**RE: Sub-Slab Depressurization System and Soil Vapor Intrusion Work Plan
Addendum #1
Oswego Midtown Plaza – C738045
18 East Cayuga Street & 83-87 East First Street, Oswego, New York
LaBella Project #2200482**

DRAWING TITLE
SUB-SLAB DEPRESSURIZATION
SYSTEM LAYOUT - AS-BUILT

R-100
1/8" = 1'

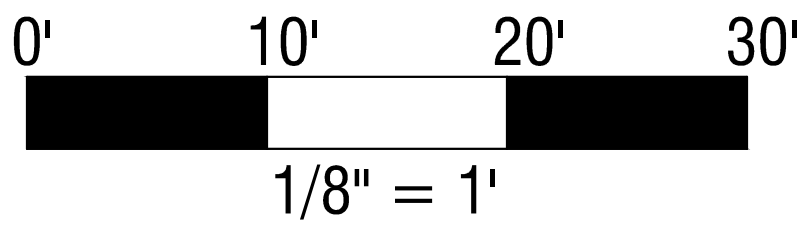
The SSDS was activated on July 22, 2021 and LaBella collected PFE readings in late August and early September 2021. The PFE readings have shown consistent negative pressures at MP-02 through MP-08, indicating the SSDS is working correctly. However, the PFE readings for MP-01 were consistently positive. On October 7, 2021, LaBella drilled two holes through the concrete floor slab to the east and west of MP-01 and collected PFE readings directly from those points. These measurements were -0.005” (Inches Water Column) WC and -0.007” WC, respectively. These negative pressure measurements indicate that the SSDS is operating sufficiently in the area of MP-01. Based on these results, it appears that MP-01 was damaged during construction and is no longer a viable sampling point.

As it has been demonstrated that MP-01 is no longer viable, we would like to remove MP-01 from the PFE monitoring list. Given that there are still seven viable PFE monitoring points which provide coverage throughout the building footprint and the complications of monitoring a point that would need to be installed within an apartment if MP-01 were replaced, LaBella is not recommending the replacement of MP-01.

In addition, as part of future SVI sampling, LaBella had planned to sample sub-slab vapor using monitoring points MP-01 through MP-05. Given that MP-01 is no longer viable, we would like to sample from MP-08 instead of MP-01. The final sampling locations would be MP-02, MP-03, MP-04, MP-05 and MP-08 and will still provide representative coverage of the building footprint. This change to the sampling plan will be identified as a deviation in the letter to be submitted following the SVI sampling.
